ALTERATION TO A HISTORIC PROPERTY STAFF REPORT

Site / District(s): 10 Westwood Road c. 1897 Edward Jackman House

Case: HPC 2013.032 Westwood Road Local Historic and National

Legal Notice: Replace iron handrails with wood rails, balusters and newel posts

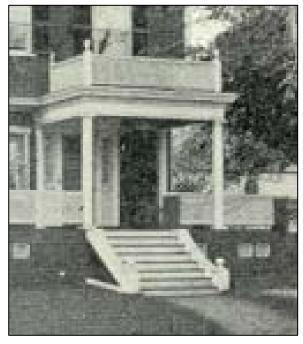
As can be seen in the historic photo, the house did not originally have handrails, and the newel posts were heavier and shorter than is commonly seen on the street. This does not meet current building code.

Somerville Past and Present does not show railings and newels but rather a wide shoulder and stubby posts with ball finials.

The proposed alteration would add handrails that are of a design consistent with the porch railings and balusters the existing porch rails and balusters. The new newel would similar to those on the upper level porch, the porch posts next door at 12 Westwood Road and those on 11 Westwood Road across the street.

Staff determines that the alteration for which an application for a Historic Certificate has been filed is appropriate for and compatible with the preservation and protection of the Bow Street Local Historic District; therefore Staff recommends that the Historic Preservation Commission grant Michael Avery a Certificate of Appropriateness to replace the existing metal hand rails and with wood handrails, balusters and newel posts consistent with the existing porch balusters and rails on 10 Westwood Road as seen on the historic photo.
